SERVICETEKNOTES

TABLE OF CONTENTS

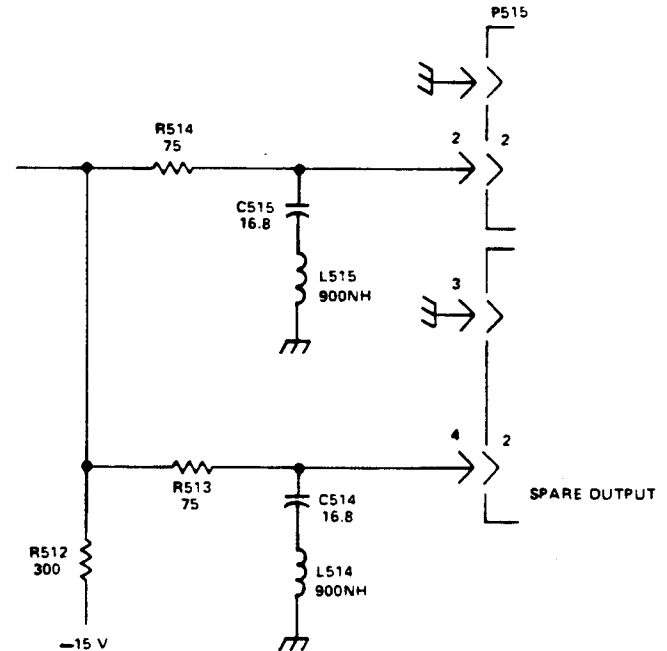
- o L514 (P/N 108-0683-00) was added, "teepee" fashion, in series with C514
- o L515 (P/N 108-0683-00) was added, "teepee" fashion, in series with C515.

The schematic below illustrates the circuit changes.

Figure 1

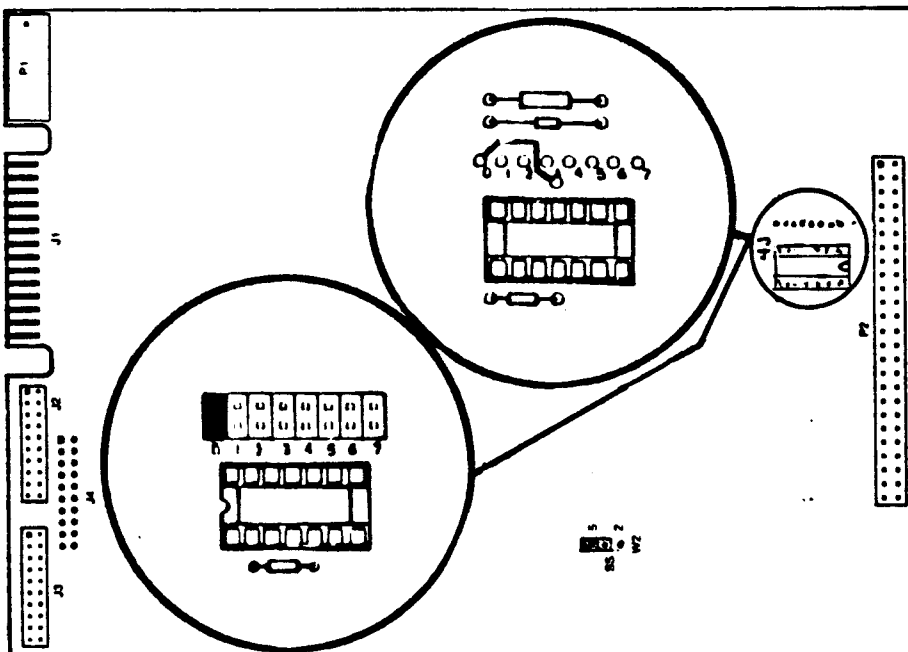
The 670-8437-00 rolled to -01 when the wire jumper at board location 4J, to select a device address, changed to a double row of pins and a moveable jumper, see figure 1. Xebec rolled the board assembly number from 104526 to

Configuring the Winchester controller is a matter of selecting the proper device address. The default device address is zero (0) as shown in the two exploded views on the Winchester controller board, figure 1. However, when connecting multiple devices, each device must be at a different device address. This requires the user to choose the device address. Device address 7 is always reserved for the host controller, such as the MSIB I/F (Option 45).

Sector size should be set for 512 bytes, strap W2 (on the 104526) or W2(on th- 104527) should be set at 5, as shown in Figure 1.

T.V. Pattern Generator Connector

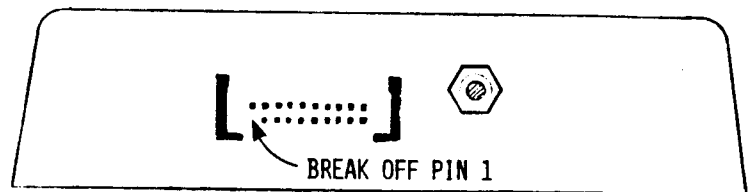
The ribbon cable from the T.V. Pattern Generator is polarized at the 4692 end to prevent reversal. Unfortunately we failed to polarize it at the other end and it can still be reversed, which typically blows two axial lead fuses, F851 and F855 (P/N 159-0090-00), on the 4692 Drive Module.

To prevent this occurrence, you can easily polarize the plug at the test fixture end. Use a needle-nose pliers to "wobble" and break off pin 1 at the test fixture. Insert a plug, P/N 134-0153-00, into pin 1 on the ribbon cable (it is marked with an arrow and is on the red stripe side). See the figure below.

Fig. 1. Schematics for locally constructed test equipment

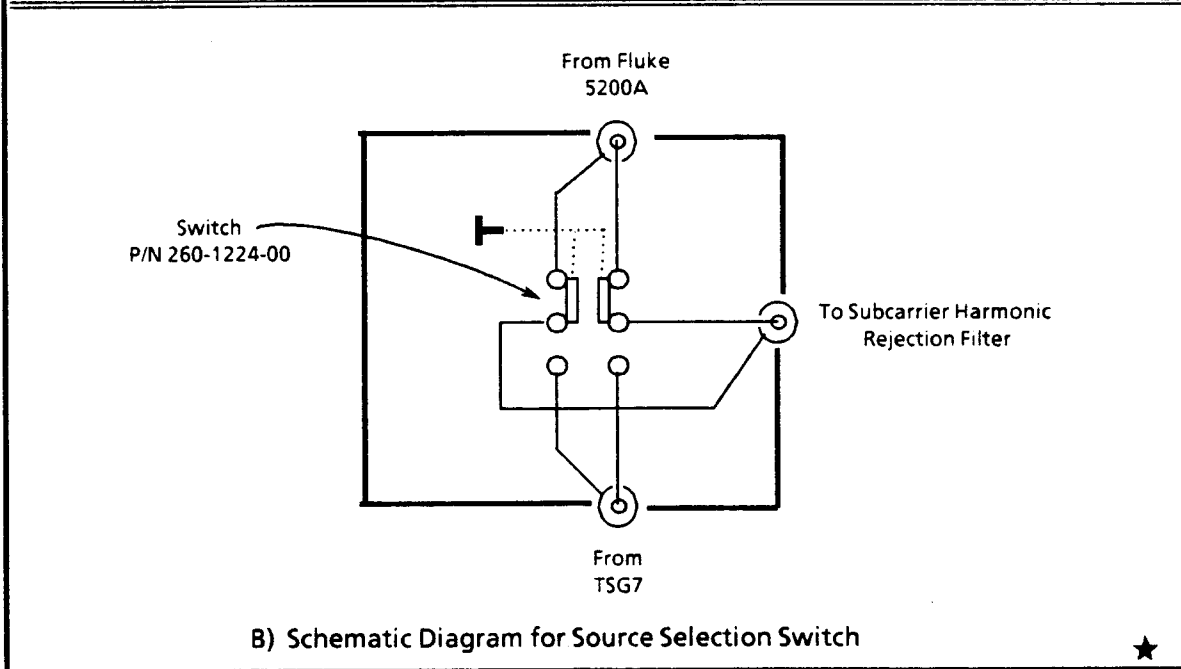
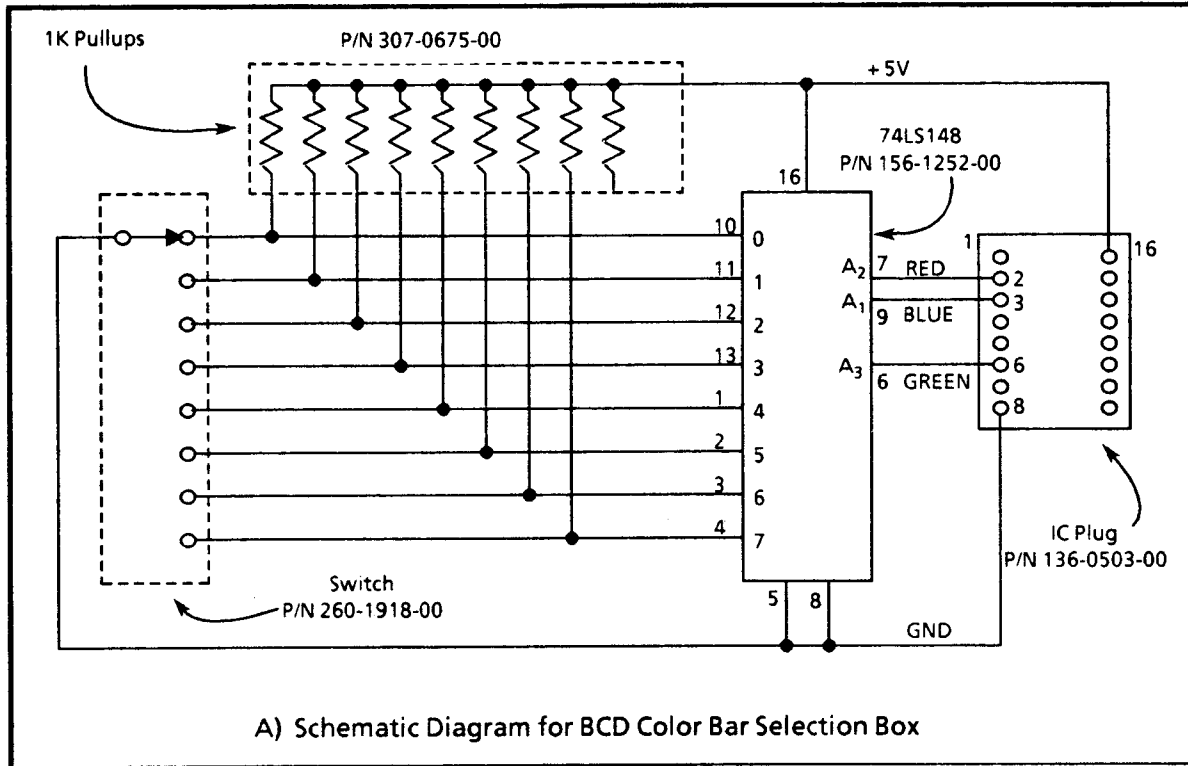
CHANGE Fig. 1 AS FOLLOWS:

Fig. 2. Equipment Connections for Chrominance Amplitude Measurement.

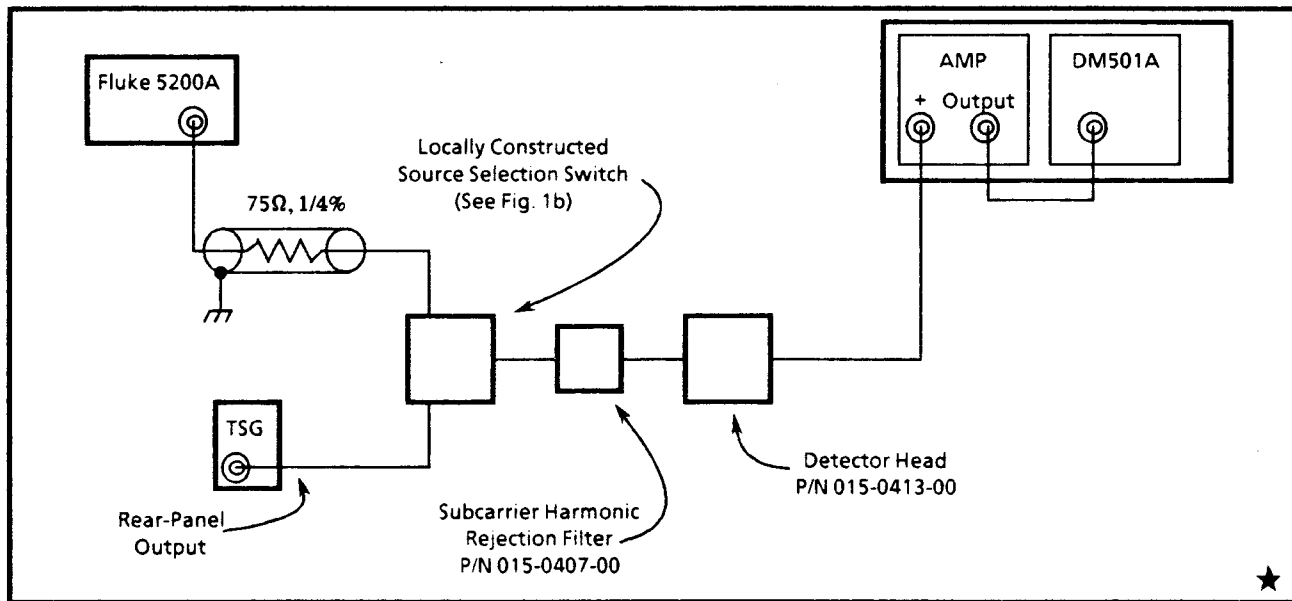
CHANGE Figs. 2 and 3 AS FOLLOWS:
